RESPONSE TO AUDIT ISSUES

APR1400 Topical Reports

Review Section	TR Realistic Evaluation Methodology for LBLOCA of the APR1400
Application Section	Topical Report: APR1400-F-A-TR-12004 Realistic Evaluation Methodology for Large-Break LOCA of the APR1400
Issue Date	08/13/2015

Audit Issues No. 27-k

Figure 1. Nodalization of Pressurizer Surge Line

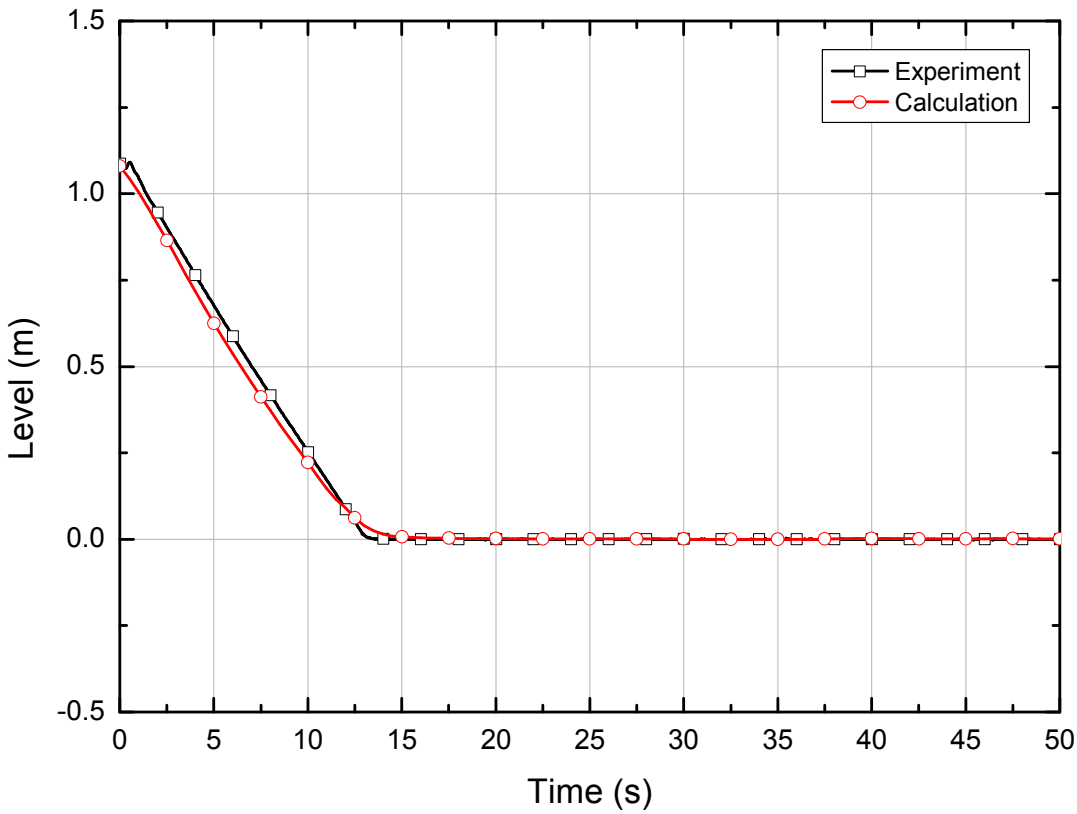
- k. In order to adequately simulate the depletion time of the pressurizer and liquid drainage during the blowdown period, the nodalization of the pressurizer surge line should be consistent with the actual plant geometry. However, the description for the pressurizer surge line nodalization is not provided in Section 4.2.1 of the topical report. According to the RELAP5 base model input deck, the surge line is modeled using a single inclined hydraulic component. Additionally, the loss coefficient through surge line pipe is set to be computed by the code which neglects the turns and orientation changes in the line. Justify the selected nodalization and loss coefficients including any references to nodalization sensitivity studies comparing the pressurizer flow into upper plenum against the available special effects tests and/or integral effects tests data.

The surge line of pressurizer is modeled as a SNGLVOL component as show in Figure 1 and the detailed information of surge line are as follows.

In order to predict the depletion of pressurizer, the pressurizer and surge line are modeled as PIPE component with []TS and SNGLVOL component respectively to reflect the assessment result against LOFT test. Figure 2 shows the pressurizer level. It is confirmed that the calculation result using this nodalization is adequately predicted comparing to the result of LOFT test. Based on the result, the nodalization of pressurizer and surge line mentioned above is used in the plant calculation.
